BID ADDENDUM NO. 1

City of Auburn, Maine
Sopers Mill Road Culvert Replacement
January 21, 2021

Notice is hereby given that Addendum No. 1 provides further clarification for questions asked by Bidders before and during the Pre-Bid meeting held on January 19, 2021 and includes the registered bidders list. Bidders are instructed to acknowledge receipt of this Addendum by inserting its number and date in the "Acknowledgement of Bid Amendments".

100-year storm event water surface profile:

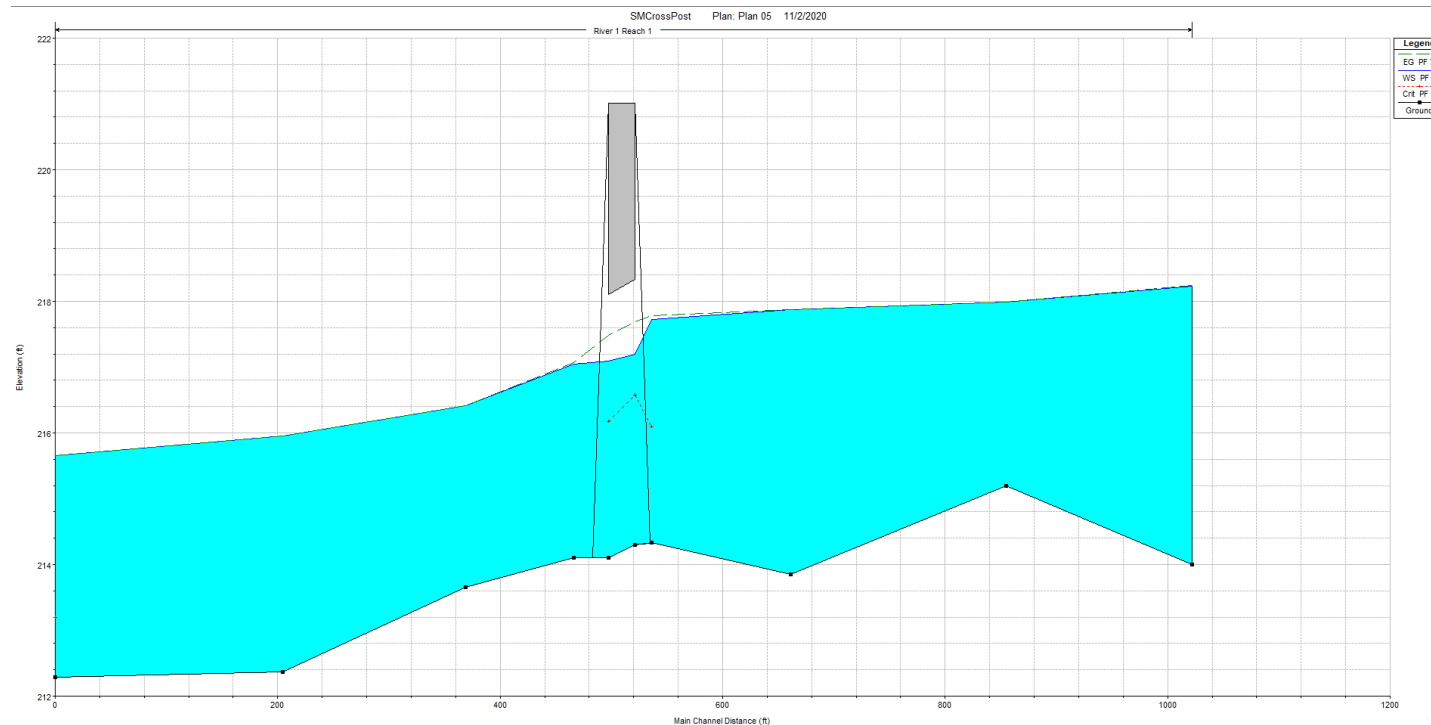
1. Was there any hydrologic information prepared for the project.
Answer: Yes, a copy is included with this addendum.
2. Was any geotechnical investigations completed for the project.
Answer: No

HEC-RAS Hydraulic Analysis Program provides basin flow estimates and culvert discharge results for the following rainfall events at the proposed box culvert design, and indicates that the proposed culvert will pass the expected 100-year storm event:
